Sydney Metro Northwest – Community feedback in response to the Parking Management Strategy Overview Report

Figure 4.3: Focus area – Glenhope Road (West Pennant Hills) parking conditions, early 2019

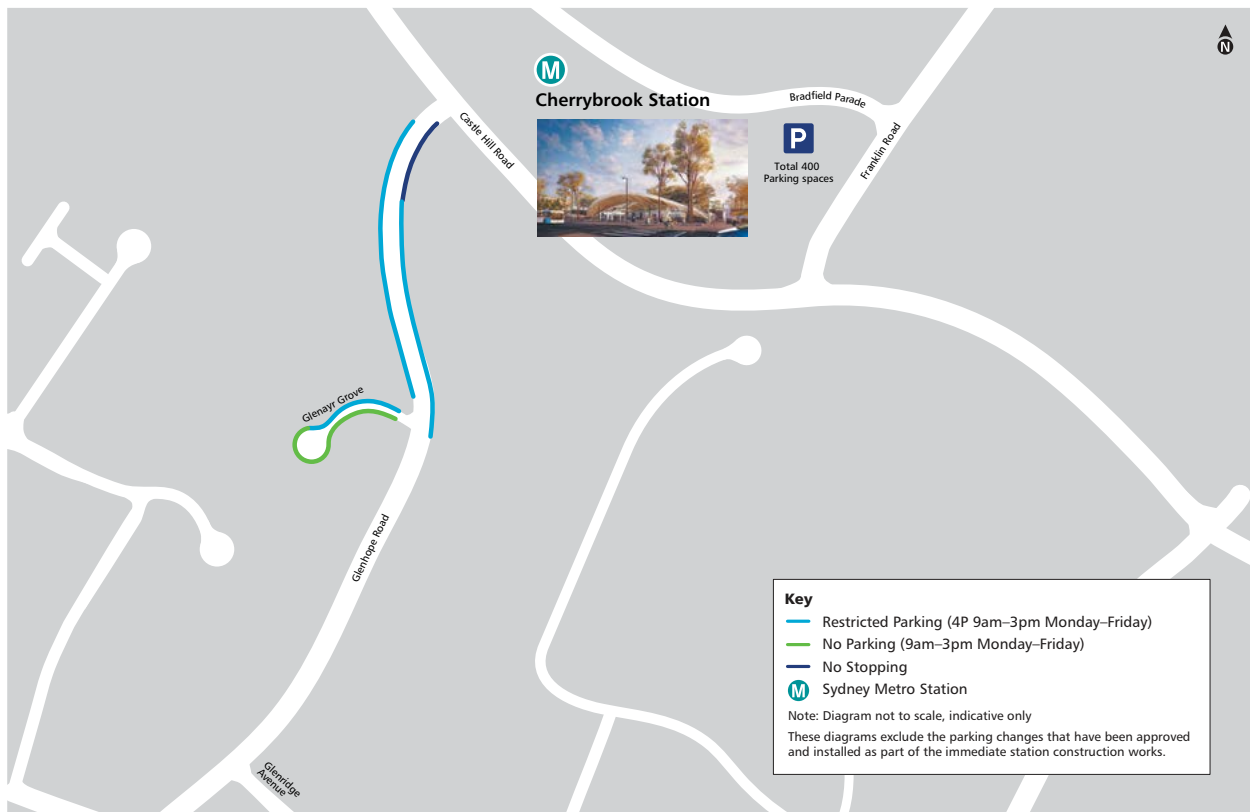
The key issues raised by the community feedback were:

- requests for resident parking schemes (raised by 38 submissions)
- enquiries or concerns regarding bus access (16)
- enquiries or misunderstanding regarding the already approved parking restrictions within or around the station precinct (16)

- requests to extend the area of the proposed parking restrictions (15)
- safety concerns (14)
- requests or comments outside the scope of this consultation (13)

- requests to increase or decrease the proposed hours of restriction or length of stay (8)
- requests to change, reduce or not implement the proposed restrictions (6)

- concerns about the consultation (5)
- commuter impacts on residential amenity (5)
- requests for the provision of additional or larger commuter car parks (3)

- lack of all-day parking available to residents as a result of the proposed restrictions (1)
- concerns regarding staff parking (1)
- concerns about over-development (1)

- ability for parking provisions to be reviewed again in the future (1).

Following consultation, Sydney Metro reviewed the community feedback and proposed some additional changes and altered some of the parking measures originally proposed. These additional changes have been included in the final recommendations to the relevant local councils for assessment and include:

- Replacing No Stopping zones with No Parking zones in the cul-de-sac ends of Ridgemont Close, Claridge Close and Fernleigh Close to allow for short-term pick up and drop off.

- Moving the No Parking zone on Ghisla Close from the northern side to the southern side.
- Adding No Parking zones to the western side of Staley Court and on the local road in front of 111-113 Castle Hill Road.

- Extending the No Stopping restriction on the western side of Franklin Road beyond the Neale Avenue intersection (in the northern direction).
- Rezoning a No Parking zone in front of Tangara School for Girls to become a No Stopping zone.

- Rezoning an area opposite Tangara School for Girls, initially proposed to be No Stopping, now proposed to be 'No Parking 8-9.30am/2.30-4pm Monday to Friday' to allow for pick-up and drop-off activity during school hours and residents parking at other times.

- Adding four-hour parking, No Parking and No Stopping zones along Robert Road between Oliver Way and Dalkeith Road. This area is in the 200-400 metre radius from the station and was not captured in the initial parking restriction assessment.

Figure 4.5: Focus area - Brisbane Road, Crane Road, Mercer Street, Castle Street parking conditions, early 2019

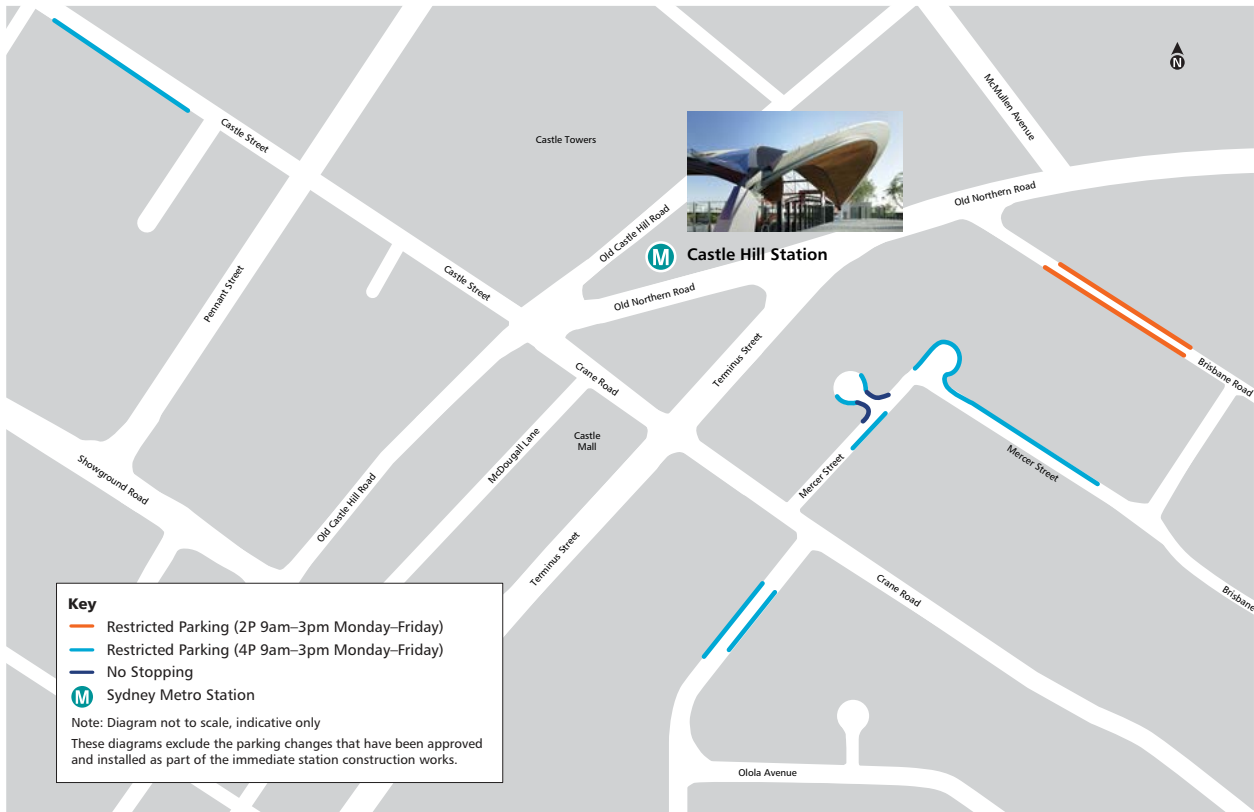
- requests for resident parking schemes (raised by 12 submissions)
- requests to extend the area of the proposed parking restrictions (9)
- safety concerns (8)
- requests to increase or decrease the proposed hours of restriction or length of stay (4)
- commuter impacts on residential amenity (3)
- concerns about over-development (3)
- enquiries around the enforcement of parking restrictions (3)
- requests for the provision of additional or larger commuter car parks (2)
- lack of all-day parking available to residents as a result of the proposed restrictions (2)
- requests or comments outside the scope of this consultation (2)
- enquiries or concerns regarding bus access (1)
- requests to change, reduce or not implement the proposed restrictions (1).

No further changes are currently proposed for the streets surrounding Castle Hill Station. Sydney Metro will monitor the performance of parking restrictions implemented for a year after the station opens.

Figure 4.8: Focus area - Brookhollow Avenue and Fairmont Avenue parking conditions, early 2019

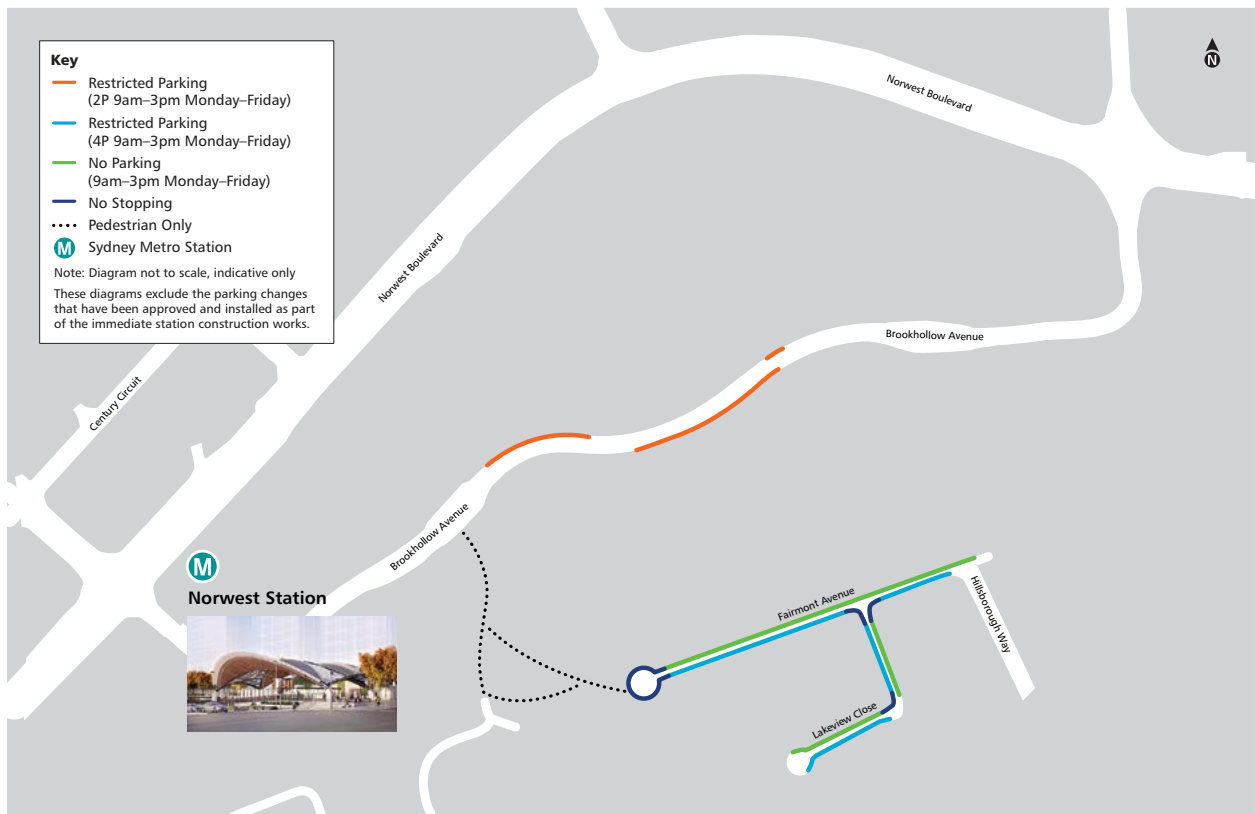
- requests to extend the area of the proposed parking restrictions (raised by 16 submissions)
- requests for resident parking schemes (10)
- safety concerns (9)
- requests to increase or decrease the proposed hours of restriction or length of stay (3)
- requests to change, reduce or not implement the proposed restrictions (3)

- requests for the provision of additional or larger commuter car parks (3)
- requests or comments outside the scope of this consultation (3)
- commuter impacts on residential amenity (3)
- enquiries or concerns regarding bus access (2)
- concerns regarding staff parking (2)
- concerns about over-development (1)
- lack of all-day parking available to residents as a result of the proposed restrictions (1)
- concerns about the consultation (1).

Following consultation, Sydney Metro proposes the extension of the No Parking zone (9am-3pm) on the eastern (footpath side) of Ridgehaven Place to up to 10 metres from the intersection with Barina Downs Road. It also proposes to extend the four-hour parking zones to 600 metres from the station entrance on one side of Fairmont Avenue, Bethany Court and Hillsborough Way; and to extend the

no-stopping zone to include the complete cul-de-sac of Lakeview Close.

Due to a drafting error, the Parking Management Strategy Overview Report and consultation letters were distributed with diagrams proposing a No Parking restriction on the eastern side of Evesham Court. This restriction was intended to be four-hour parking from 9am-3pm Monday-Friday. Sydney Metro is proposing this restriction for council approval.

Figure 4.11: Focus area – Shaun Street and linking streets (Bella Vista) parking conditions, early 2019

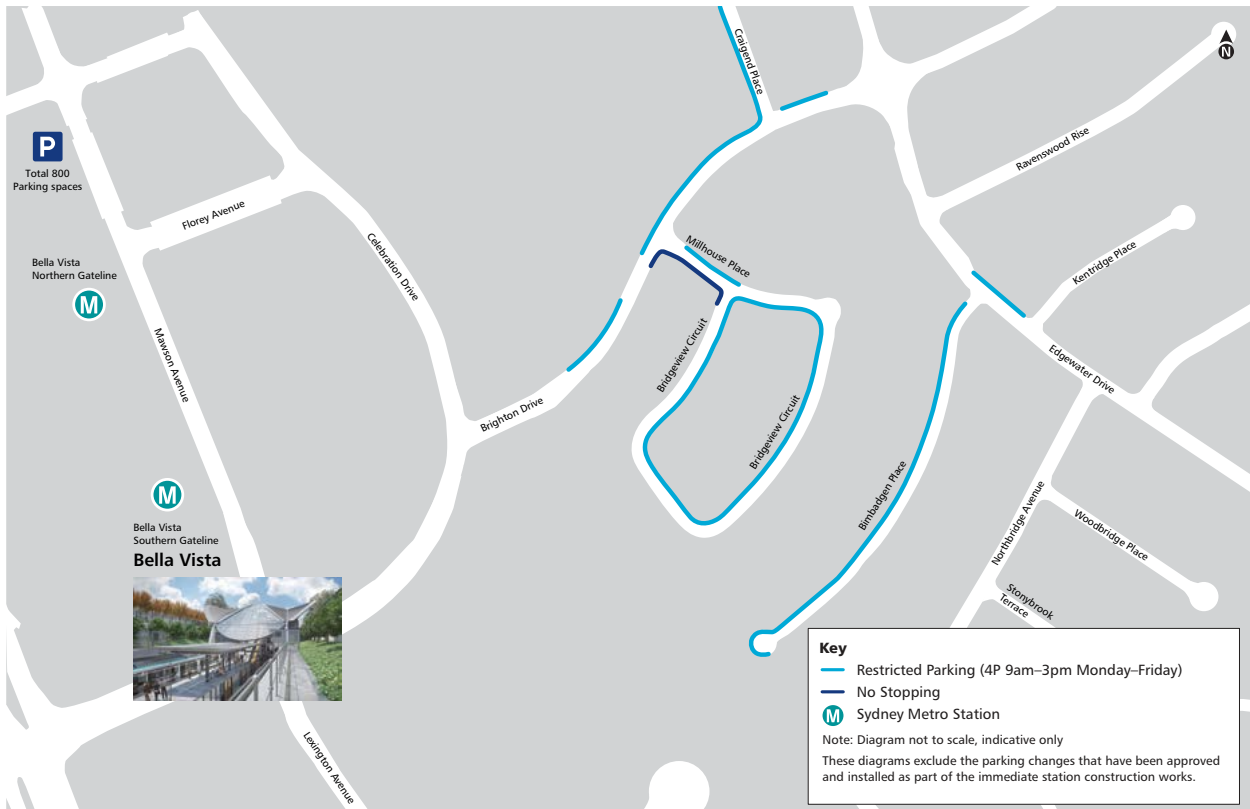
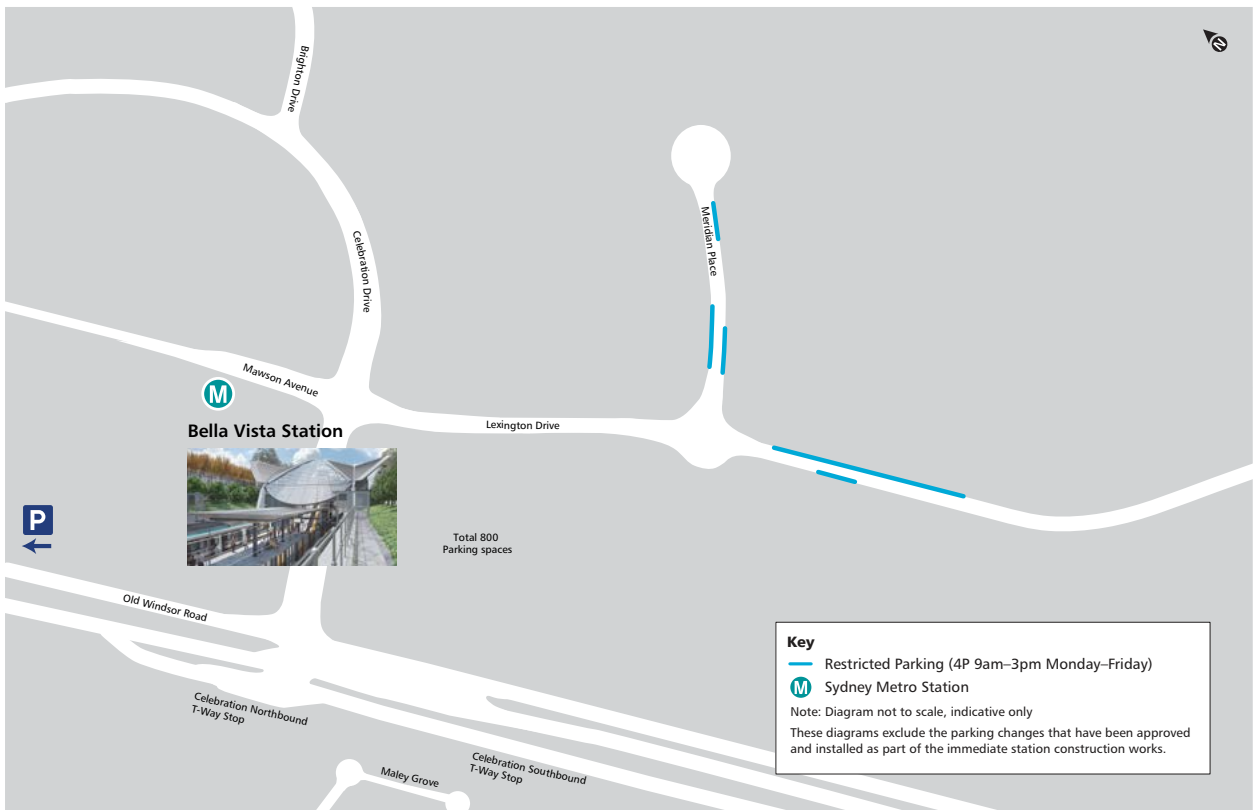
- requests for resident parking schemes (raised by 16 submissions)
- requests to extend the area of the proposed parking restrictions (8)
- safety concerns (6)
- lack of all-day parking available to residents as a result of the proposed restrictions (5)

- requests to increase or decrease the proposed hours of restriction or length of stay (4)
- requests to change, reduce or not implement the proposed restrictions (3)
- commuter impacts on residential amenity (3)
- concerns regarding staff parking (2)
- requests or comments outside the scope of this consultation (2)
- enquiries around the enforcement of parking restrictions (1).

Following consultation, Sydney Metro proposes parking restrictions be implemented on the east side of Shaun Street only.

Figure 4.13: Focus area – Kellyville Station East (Kellyville) parking conditions, early 2019

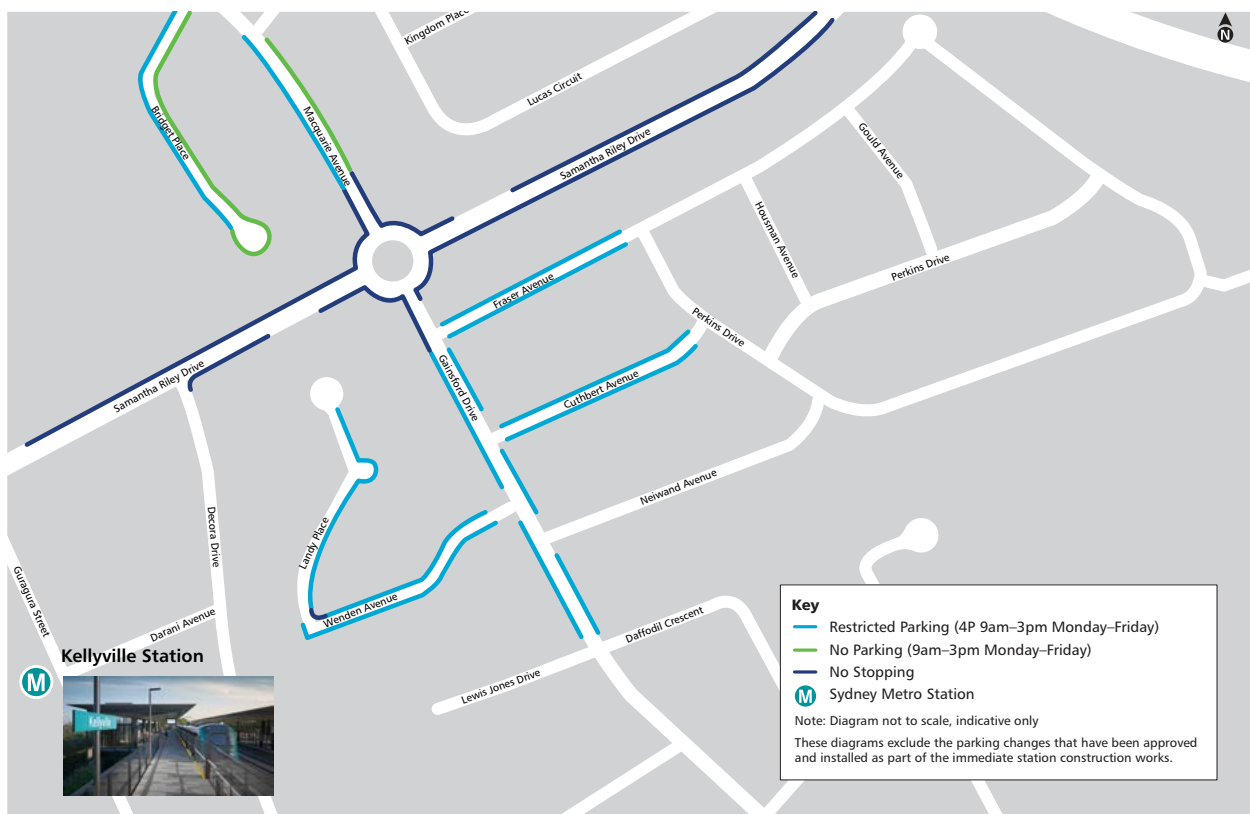
- requests for resident parking schemes (raised by 14 submissions)
- requests to extend the area of the proposed parking restrictions (11)
- commuter impacts on residential amenity (11)
- safety concerns (9)
- lack of all-day parking available to residents as a result of the proposed restrictions (8)

- requests to change, reduce or not implement the proposed restrictions (6)
- requests or comments outside the scope of this consultation (5)
- concerns about over-development (3)
- requests to increase or decrease the proposed hours of restriction or length of stay (2)
- concerns about the consultation (2)
- concerns regarding staff parking (1).

No further changes are currently proposed for the streets surrounding Kellyville Station. Sydney Metro will monitor the performance of parking restrictions implemented for a year after the station opens.

Figure 4.16: Focus area – Rouse Hill South parking conditions, early 2019

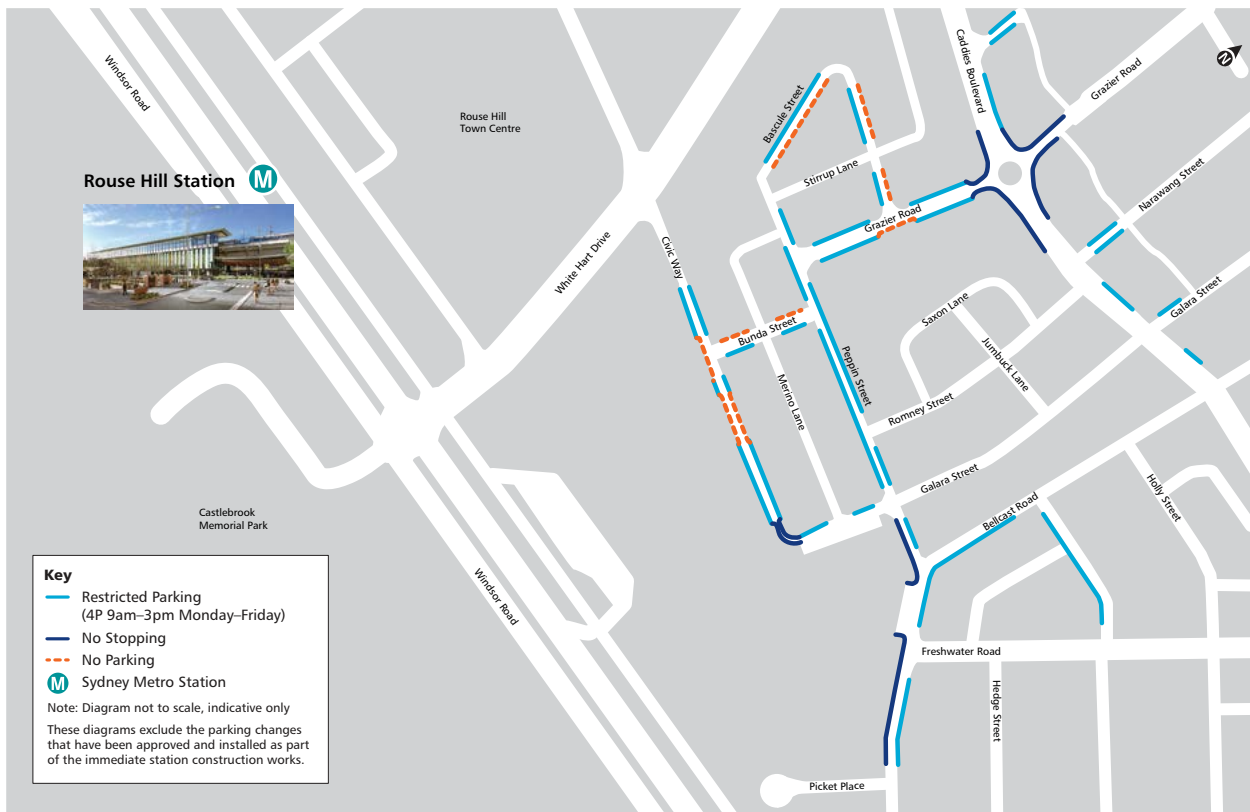
- requests to extend the area of the proposed parking restrictions (raised by 29 submissions)
- requests for resident parking schemes (21)
- safety concerns (20)
- commuter impacts on residential amenity (18)
- requests for the provision of additional or larger commuter car parks (15)
- requests or comments outside the scope of this consultation (13)

- enquiries around the enforcement of parking restrictions (13)
- requests to increase or decrease the proposed hours of restriction or length of stay (6)
- lack of all-day parking available to residents as a result of the proposed restrictions (3)
- enquiries or concerns regarding bus access (2)
- requests to change, reduce or not implement the proposed restrictions (1)
- concerns regarding staff parking (1)
- concerns about the consultation (1).

No further changes are currently proposed for the streets surrounding Rouse Hill Station. Sydney Metro will monitor the performance of parking restrictions implemented for a year after the station opens.
